# A63 Castle Street Improvement, Hull

## DCO Documents Errata

TR010016/APP/6.1  
HE51408-MMSJV-GEN-S0-RP-ZH-000016  
5 August 2019

**ES Table 11.20: Significance of potential residual impacts on surface water features during operation (amend row)**

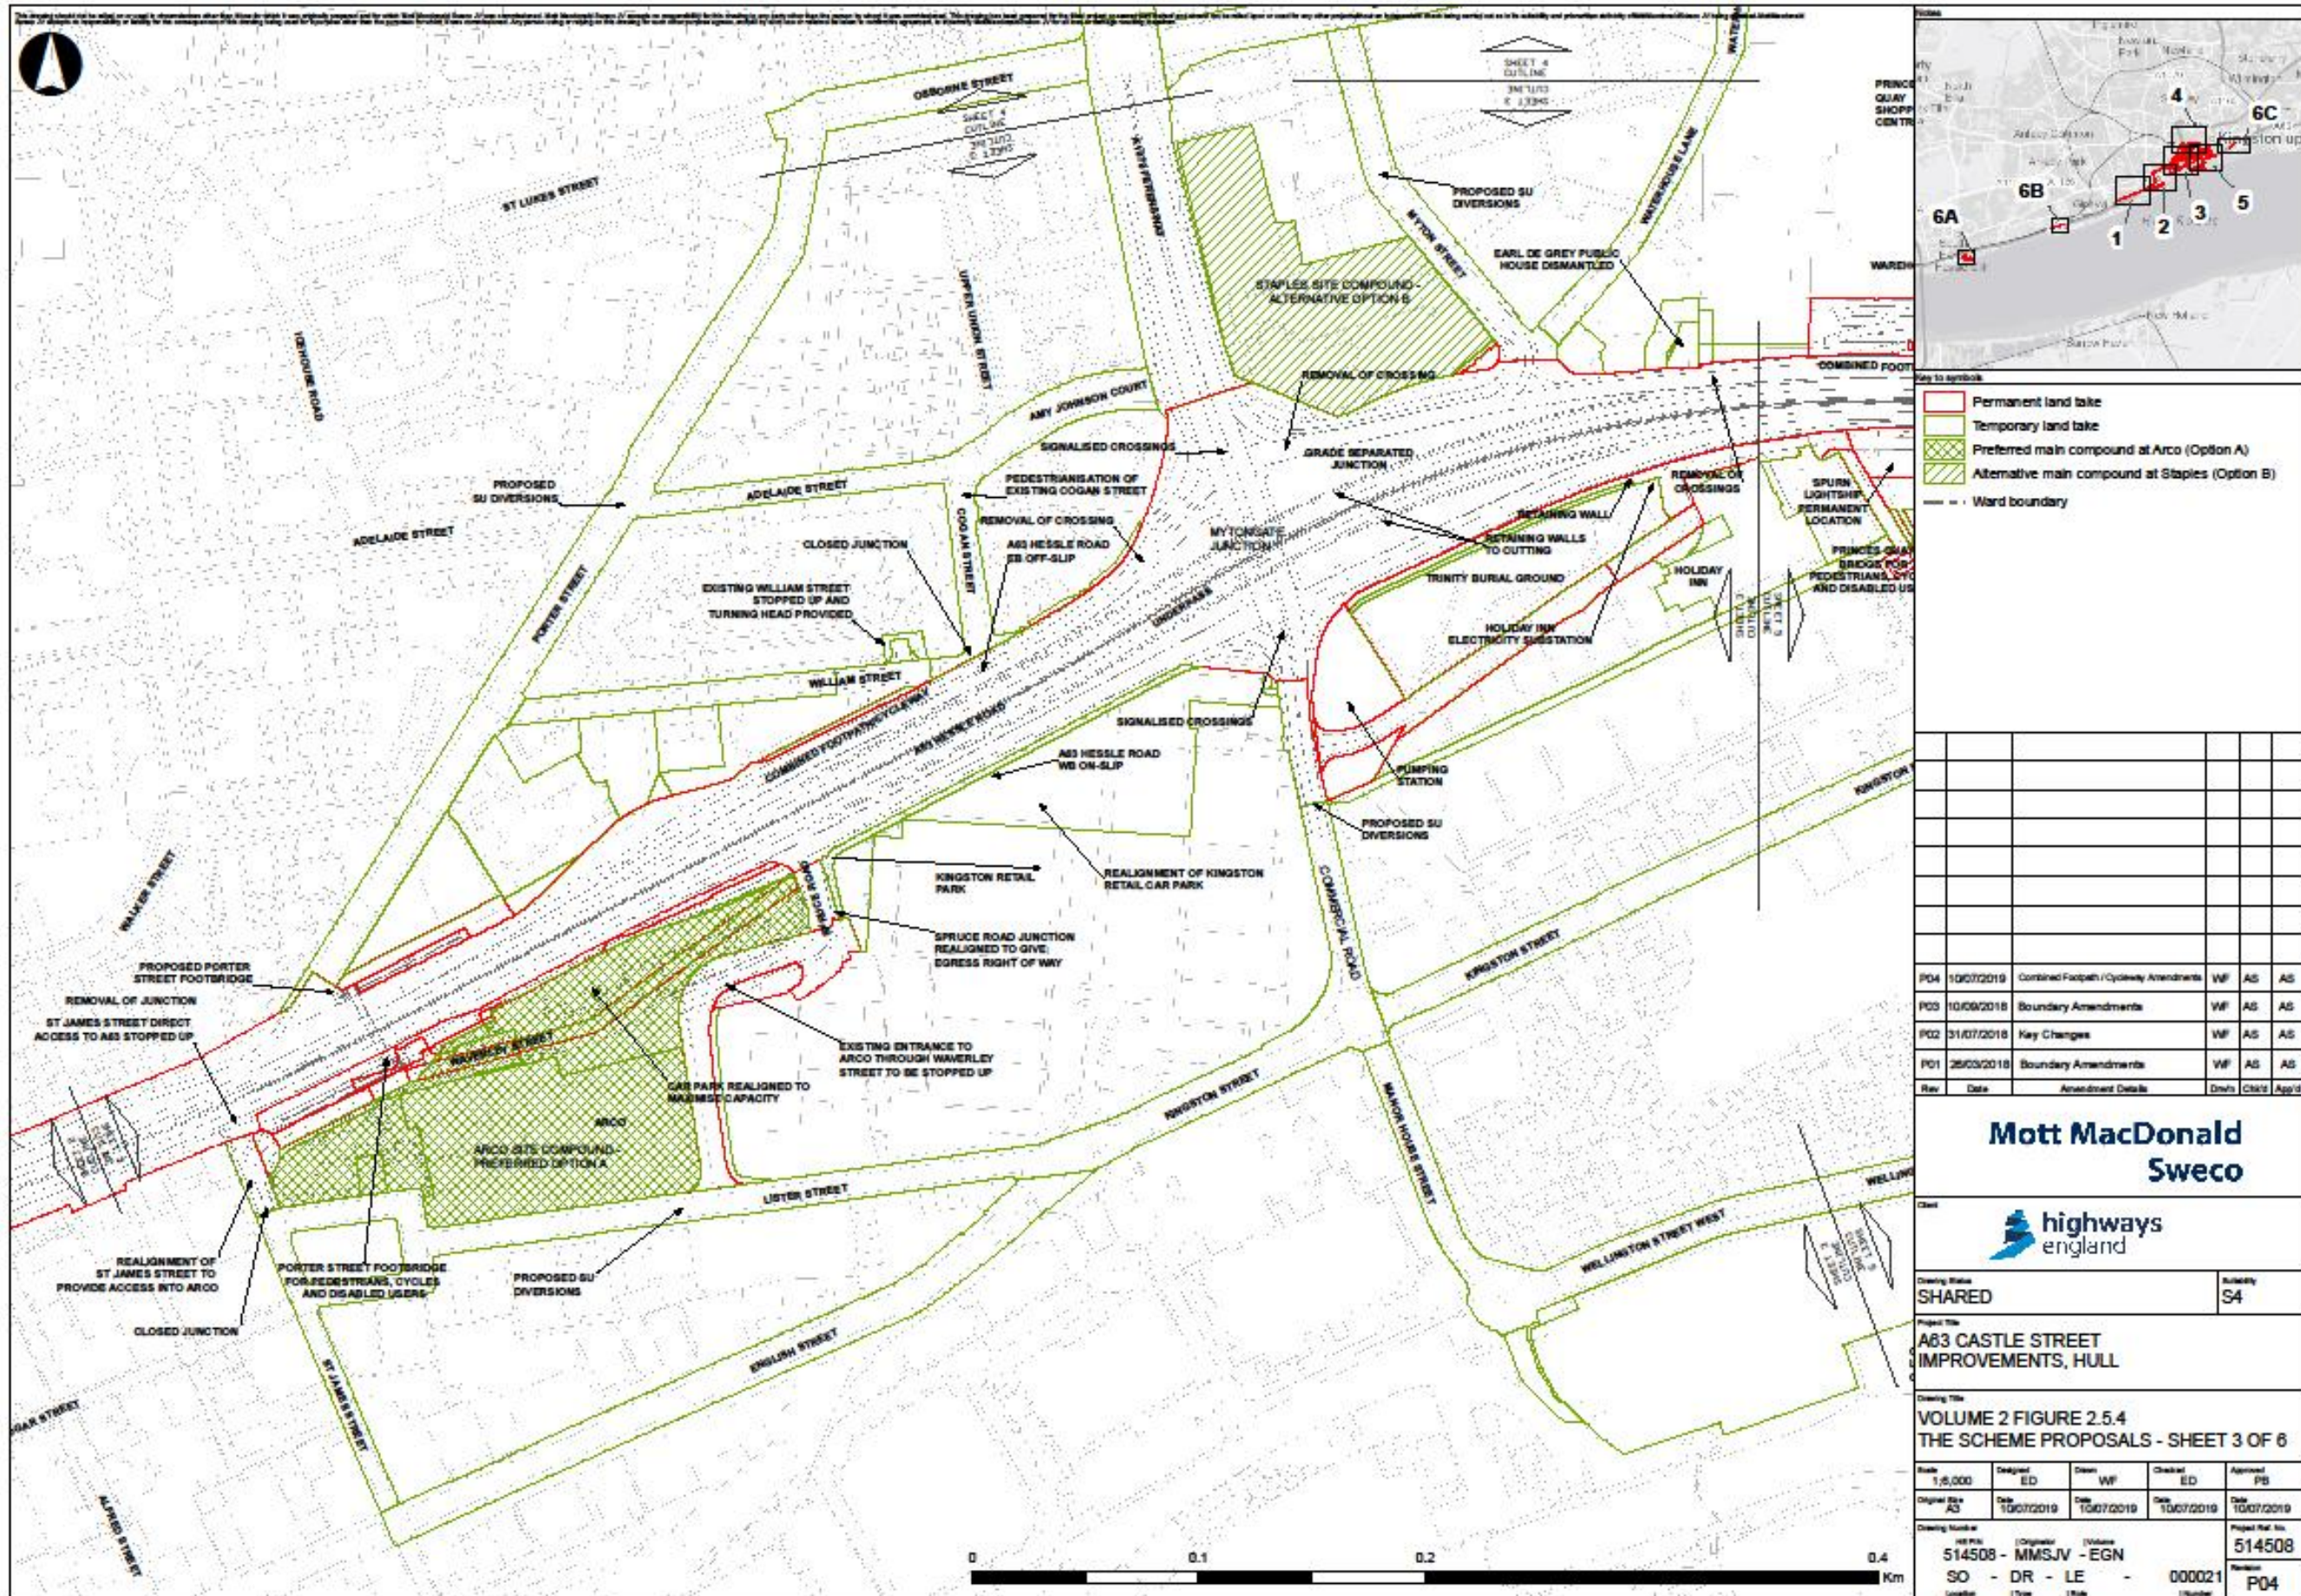
Potential Impact	Feature	Attribute	Quality	Importance	Mitigation	Magnitude of impact	Significance
Alteration of flood flow routes due to the changes in ground levels and construction of structures	Humber floodplain	Conveyance of flow	Properties within the floodplain	Very high	Underpass drainage designed for 1 in 100-year, plus 30% allowance for climate change, rainfall event.  Emergency procedures in case of pump failure or extreme flooding event including no/minimal warnings in the event of a flood defence breach (Flood Emergency and Evacuation Plan (FEED)).	Ranges from <del>Moderate</del> Major beneficial to Major adverse depending on the location, source and extent of flooding and return period of event. Further detail is provided in <b>Error!</b> <u>Reference source not found.</u> Table 11.18.	Very Large adverse to <del>Large/Very Large</del> Very Large beneficial

Volume Title: VOLUME 2 FIGURE 2.5.4 THE SCHEME PROPOSALS - SHEET 3 OF 8

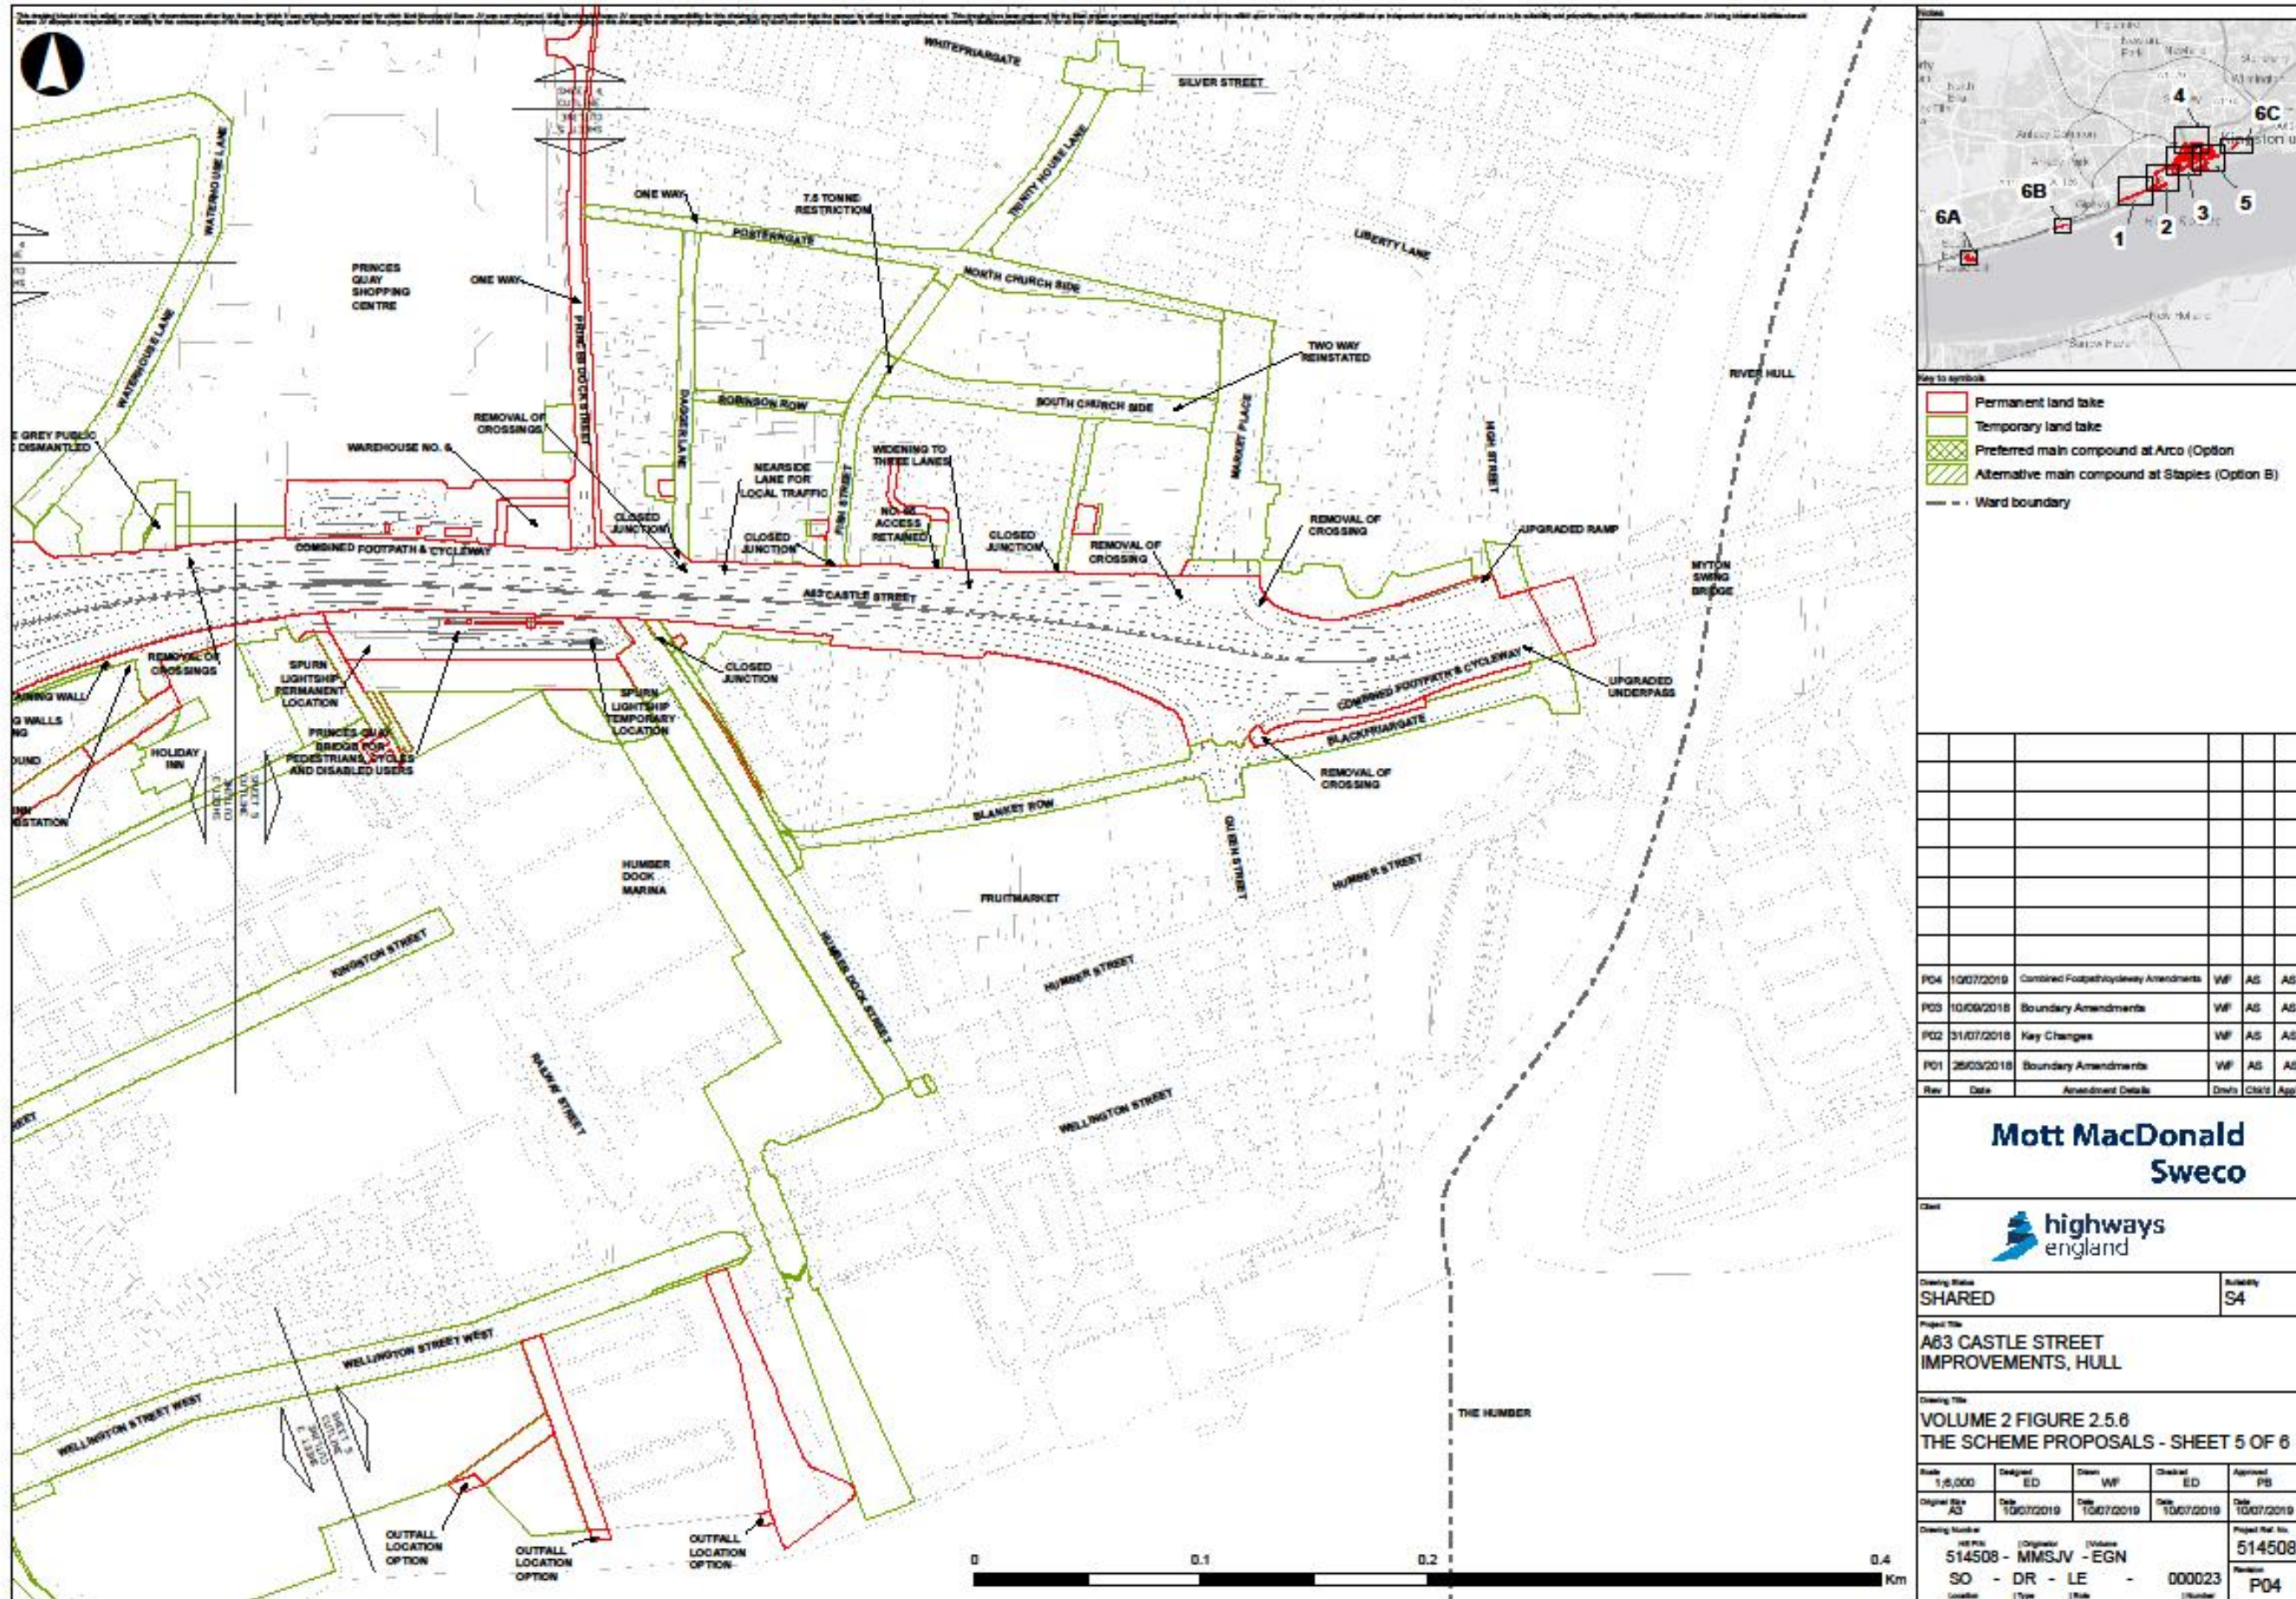
3.1.1 Replace ES Volume 2 Figure 2.5.4 The Scheme Proposals – Sheet 3 of 6 and Figure 2.5.6 The Scheme Proposals – Sheet 5 of 6 (APP-025) with the new Figures 2.5.4 and 2.5.6 below. Changes are as follows:

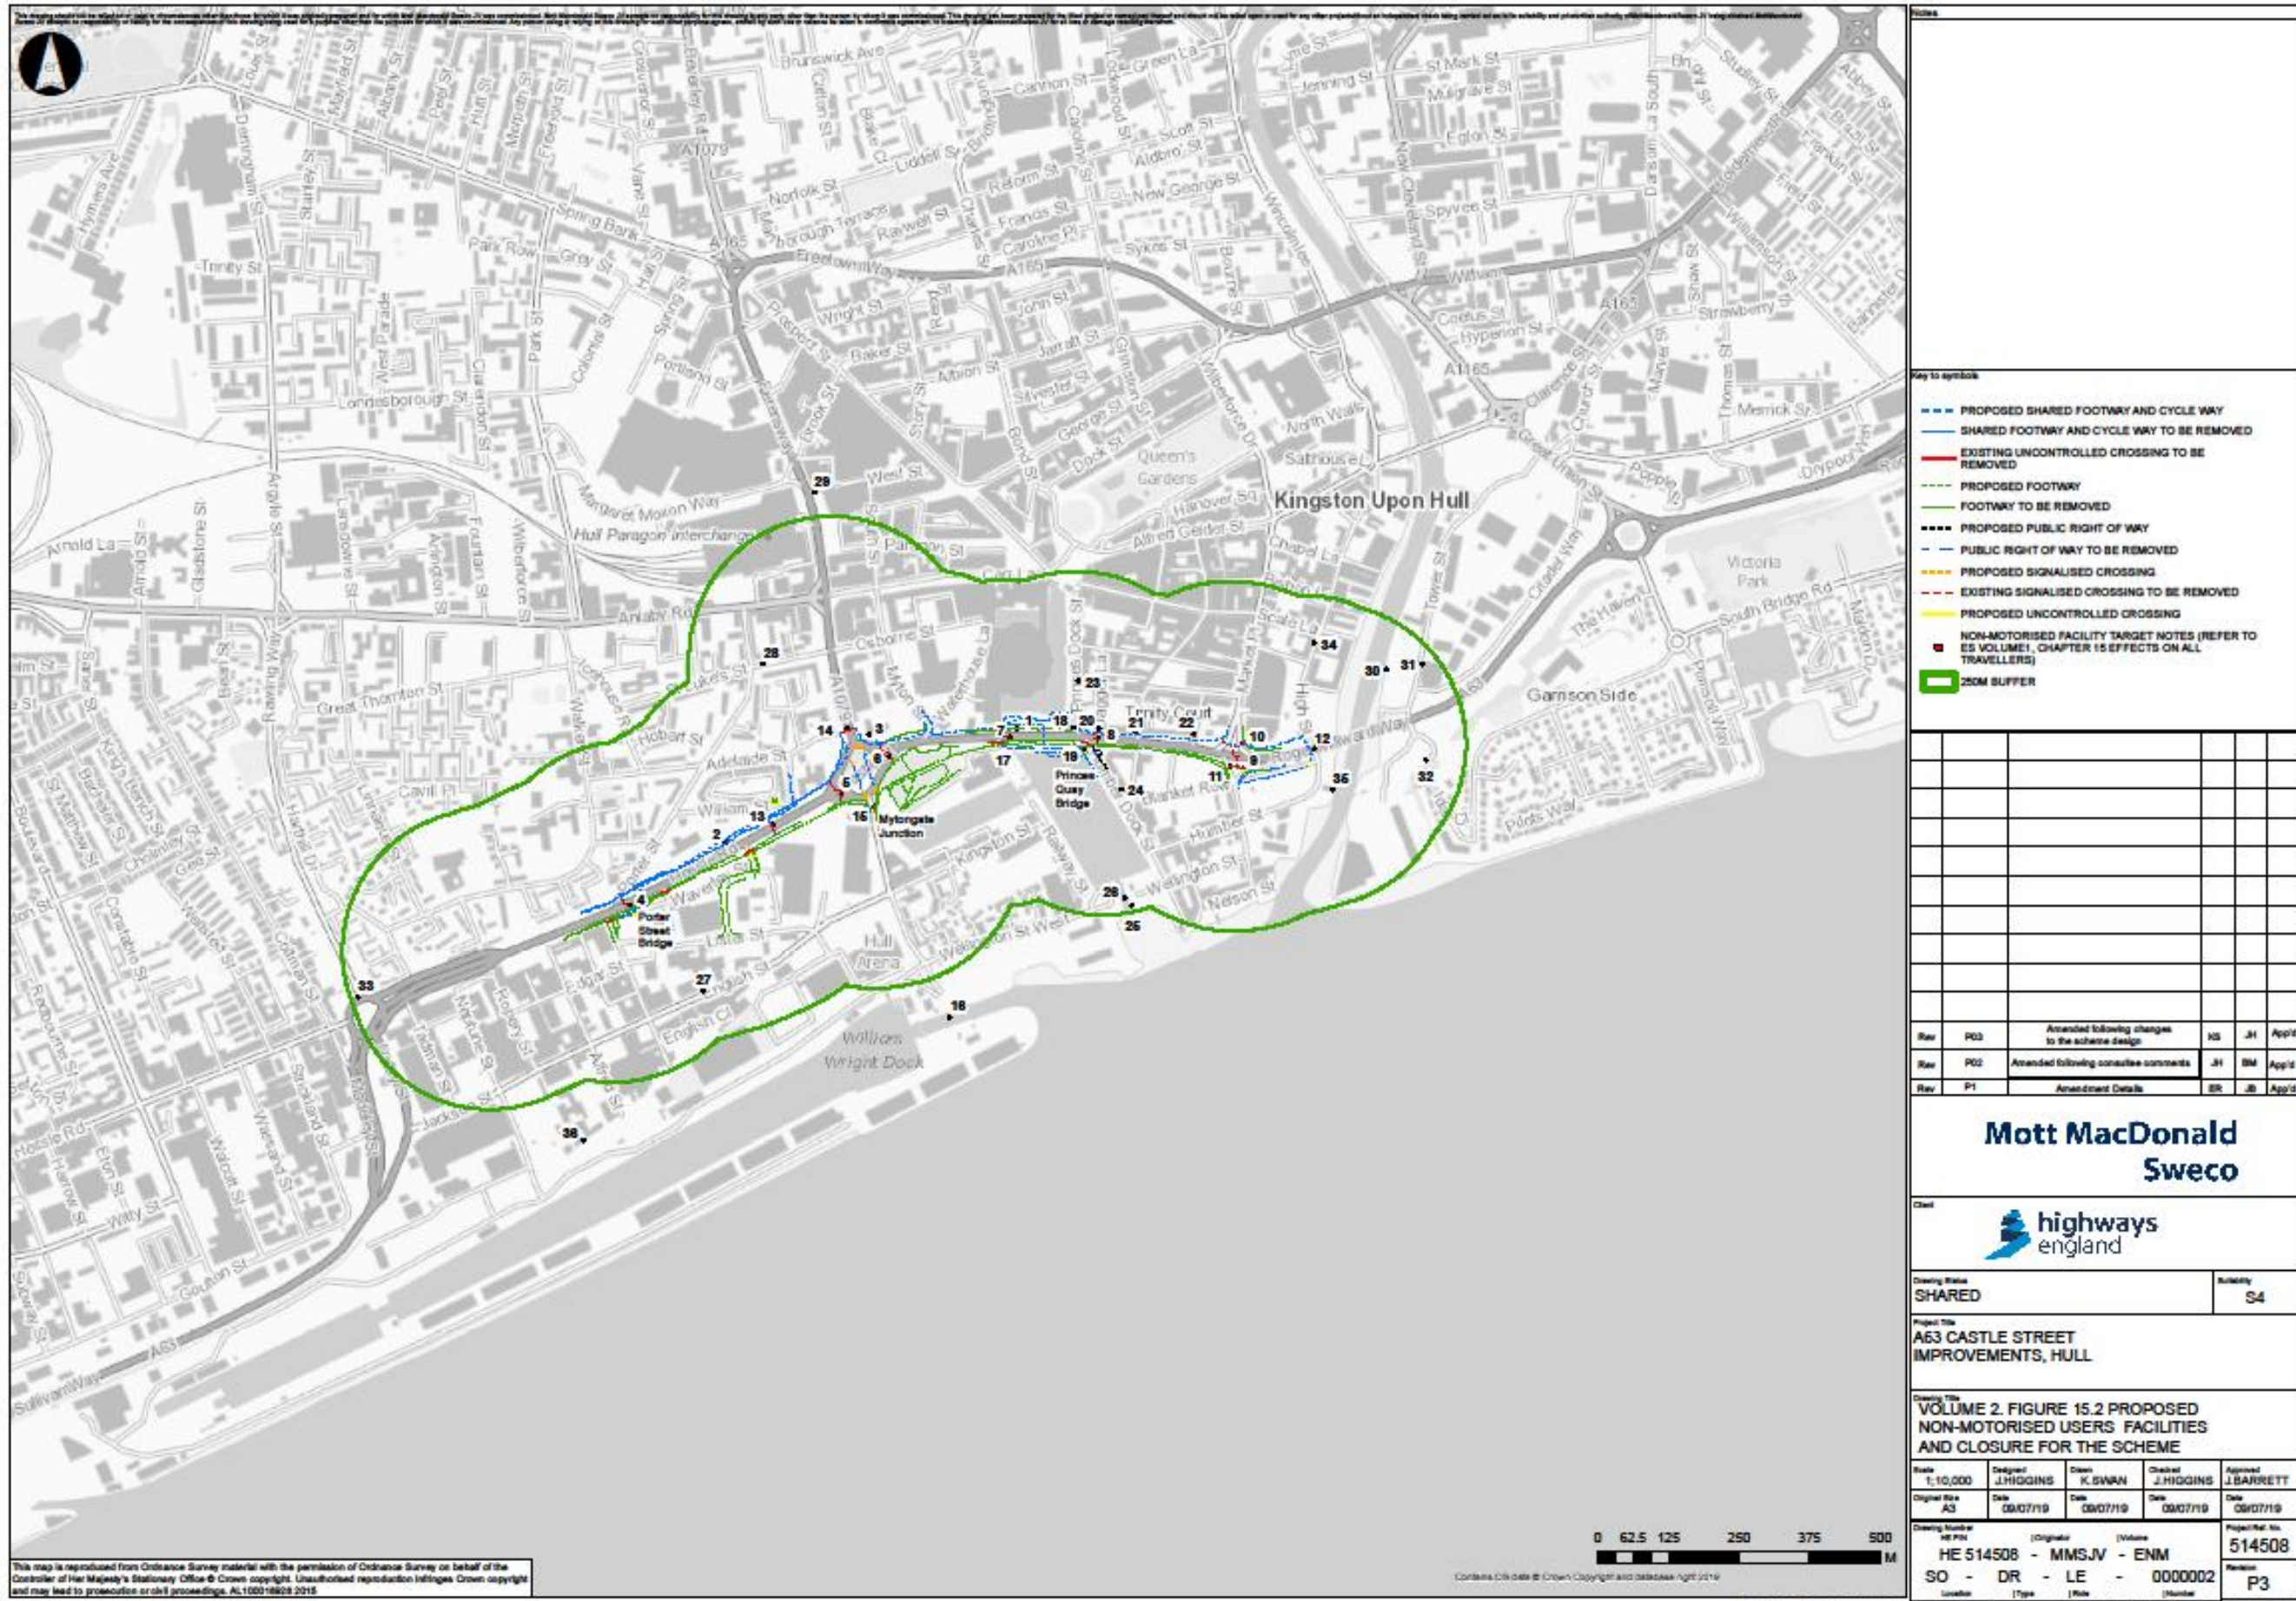
5.1.1 Replace ES Volume 2 Figure 15.2 Proposed non-motorised users facilities and closure for the Scheme (APP-040) with the new Figure 15.2 as below. Changes are as follows:

- . Locations of the combined footpath & cycleway have been clarified.
